Re: St. Lucie Unit 2
Docket No. 50-389
Order (EA-03-009)
Request for Additional Information Response
Relaxation Request No. 3

**RESPONSE TO NRC REQUESTS FOR ADDITIONAL INFORMATION
ST. LUCIE UNIT 2 RELAXATION REQUEST NO. 3
FROM THE FIRST REVISED NRC ORDER EA-03-009**

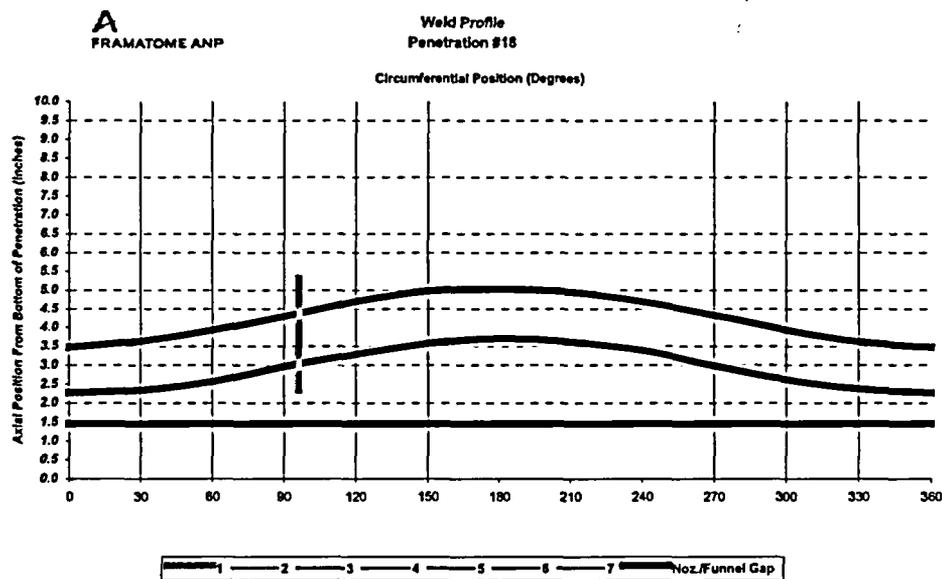
NRC Question 1: *The proposed alternative invokes a supplemental examination by nonvisual nondestructive examination on nozzles with less than 0.50-inch ultrasonic coverage below the J-groove weld. Since the First Revised Order EA-03-009 requires examinations to 1 inch below the J-groove weld provided the stress level at below 1 inch is less than 20 ksi, please justify use of the 0.50-inch criterion, which will limit the supplemental examinations to only 18 nozzles.*

FPL Response to Question 1: The inspection distance below the weld toe is limited by the physical condition of the internally threaded guide cone. No technology is currently available that will increase this distance for NDE performed from the nozzle internal diameter (ID). A previous relaxation for this condition, based on hardship, was requested and approved by the NRC on May 29, 2003.¹ That relaxation request supplemented the internal UT examinations with an external (OD) surface method, for nozzles that could not be inspected to at least 0.41 inches below the weld. During the St. Lucie Unit 2 Spring 2003 refueling outage, nine nozzles were manually inspected by external PT in accordance with this criteria. These supplemental inspections resulted in total personnel exposure of 2.45 Rem.

The current relaxation request seeks approval to utilize a supplemental nonvisual NDE method on RPV nozzles for which internal UT cannot be performed to a distance of at least 0.50 inches below the weld. Based on the dimensional data collected from the prior examination,² this criteria will require that 18 nozzles be inspected by nonvisual NDE on their OD surfaces. If the 1 inch criteria of the

Order were applied, eighty-one nozzles would require supplemental surface exams.

At the time of the relaxation request, the supplemental nonvisual NDE method had not been selected. A mechanized external UT is being pursued, but this method has not been field tested at any plant and its reliability in a full scale campaign has not been established. Additionally, the schedule to deliver a separate external UT devise for eighty-one RPV nozzles could nearly double the examination time. The dose intensive manual PT is still a contingency should the external UT fail to function on some or all of the 18 nozzles. The manual PT of 18 nozzles could result in a personnel dose of approximately 4.9 Rem (based on the actual dose accumulated during the previous outage manual PT efforts). If the examination were not limited to 0.50 inches below the weld, manual PTs for 81 nozzles could result in personnel exposure of approximately 22 Rem. Therefore, a hardship or unusual difficulty, without a compensating increase in the level of quality and safety would result if the inspection were required to extend to 1 inch below the weld toe. Based on this hardship, a technical basis to limit the external nonvisual examination was pursued.

The technical justification for the 0.50 inches criteria is based on the plant specific hoop stress plots of nozzles presented in WCAP-16038-P. Specifically, Figures E-1, E-2, E-4, and E-6 of WCAP-16038-P show that the operational hoop stresses on the outside surface of the RPV nozzles drop below 20 ksi within 0.50 inches of the lowest point below the weld toe (on the downhill side). These stress conditions satisfy the stress criteria of the Order, thereby minimizing the potential for cracking to exist in the un-inspected areas of the nozzles. The 0.50 inches criteria is also justified by the crack growth rate in this low stressed area which allows a period of operation greater than 5 years. FPL is requesting an 18 month period of operation between inspections. The relaxation request states:

"A flaw tolerance approach was developed to determine the minimum coverage distance below the weld required to assure that a postulated flaw would not grow into the weld in one 18-month period of operation. The basis for the approach is documented in WCAP-16038-P (previously transmitted to the NRC) and shown in WCAP Figures 6-12 through 6-18 for the CEDMs. These figures show that for all nozzle intersection angles evaluated, if an axial through wall flaw were to exist 0.50 inches below the end of the weld, the predicted time for the flaw to grow to a point of contacting the weld would take greater than 5 years of operation."
